8th December 2011

Re: S.75W – Modification Request Sydney Adventist Hospital, Clinical Services Building (MP10_0070 MOD 2)

C - CLINICAL SERVICES BUILDING

Figure 42: Viewing point 13 photomontage. Located on The Cornerstone Parkway, Wahroonga facing the south-west facade of the existing hospital.

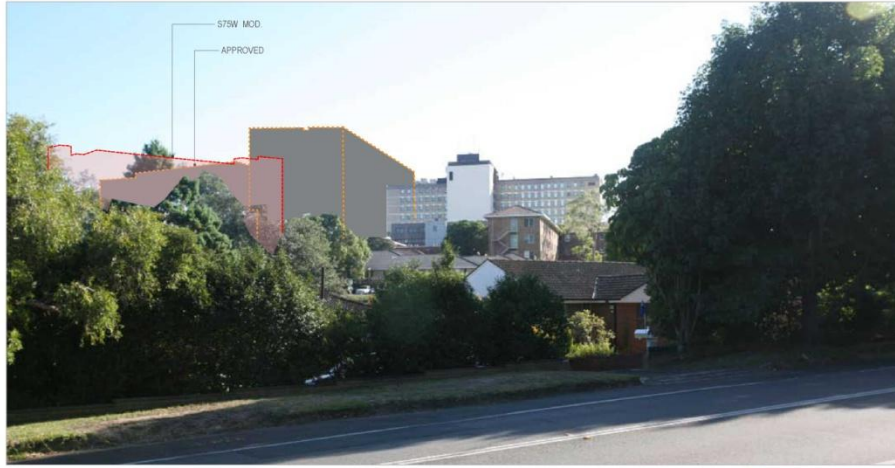
VIEWING POINT 13 (S75W MOD.)

Noticeable change, high visual impact expected.

Analysis demonstrates that the proposed additions to the hospital are screened by existing vegetation and residential buildings in the foreground. The low quality of the view due to the interruption by the existing hospital tower and nurses residence deem the visual impact of the proposal to

be of noticeable change, but with a high degree of visual impact due to the proximity of the view. It should be noted that the proposed hospital and residential buildings (southern portion of Central Hospital precinct) closer to this view point will have a greater visual impact than the current proposed additions.

Figure 45: Viewing point 16 photomontage. Located north-east of the existing hospital, where proposed residential apartments (Precinct B) have been sited in the Warragamba Estate Concept Plan.

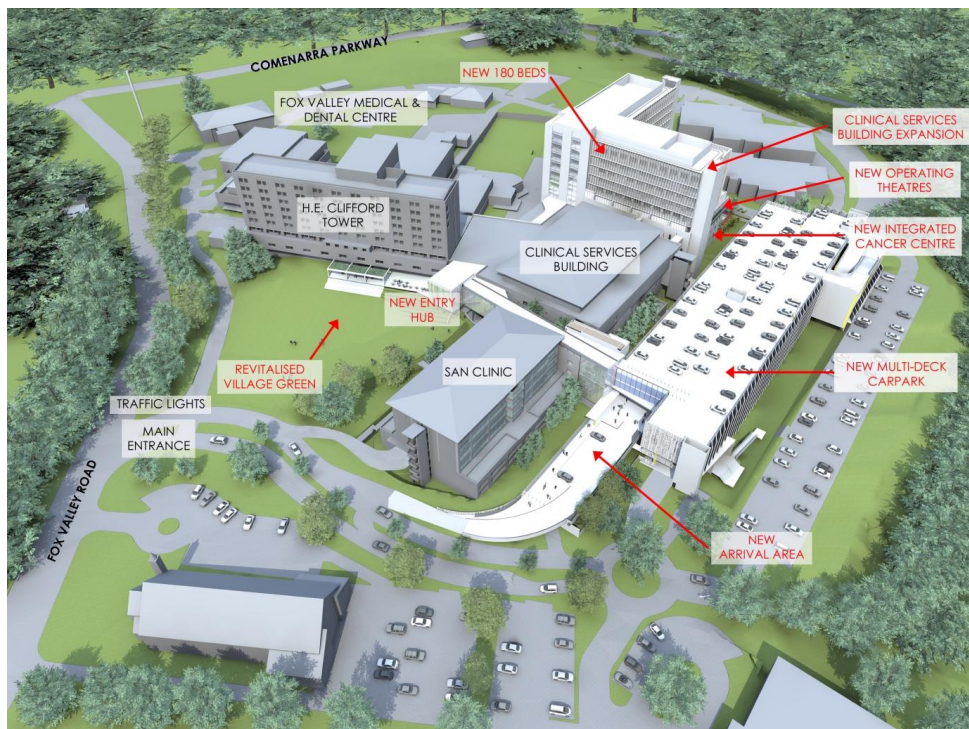
VIEWING POINT 16 (S75W MOD.)

Some change, moderate visual impact expected.

Given the low quality of view based on the presence of the existing hospital buildings and the high capacity for change, analysis demonstrates the proposed development is acceptable.

The proportion of the view that is being affected as well as the proposal being partially screened by existing vegetation and existing buildings deem the visual impact of the proposal to be of a moderate degree. Upon development of Precinct B of buildings with a maximum 20.5m height, the impact of the proposed additions will recede.
